Power supply problems with some Mark 5A units

MIT Haystack Observatory
16 August 2005

Figure 1: Bad Antec True550; fan may also be labeled “Antec”, as in Figure 2

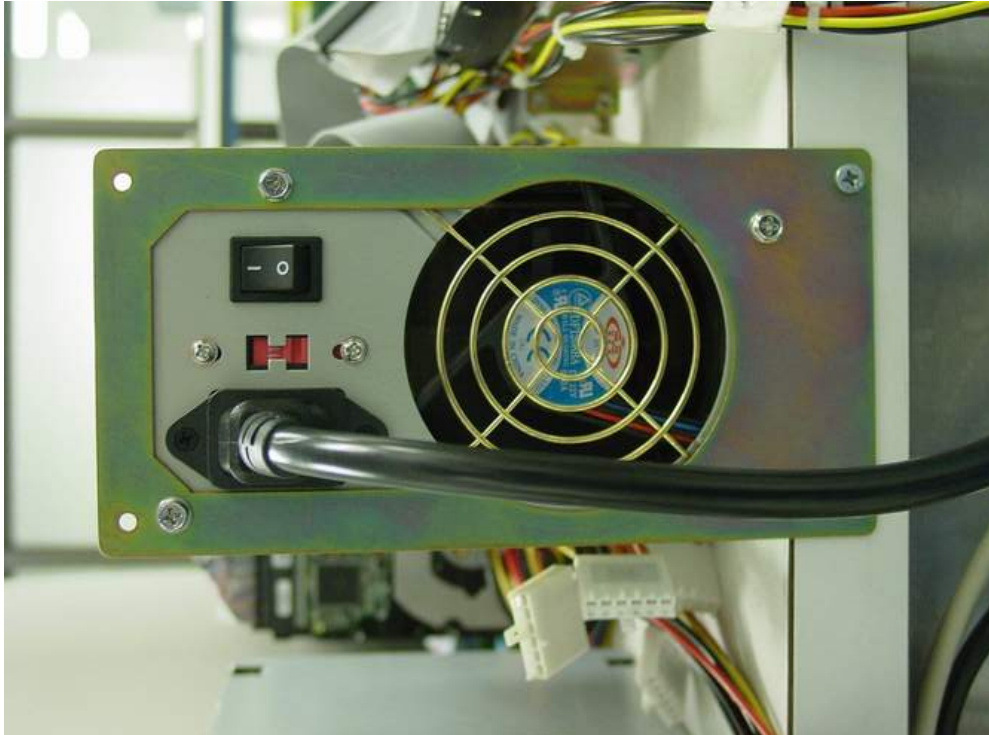
4. However, not all Antec True550 supplies are affected. Antec appears to have changed the specs on this model without changing the model number, so that only *some* Antec True550 supplies are affected. The difference is that the newer power supply, which is OK, has a "D" connector with a black plastic cover above the switch as shown in Figure 25. All good Antec supplies have this black plastic cover on the rear panel. The attached pictures should help to determine which supply you have.

5. If you need to replace your power supply, Conduant recommends the PC Power & Cooling Turbo-Cool 510XE as a replacement. We at Haystack concur with this recommendation as the quality and reputation of these supplies is outstanding, and they come with a 5-year warranty.
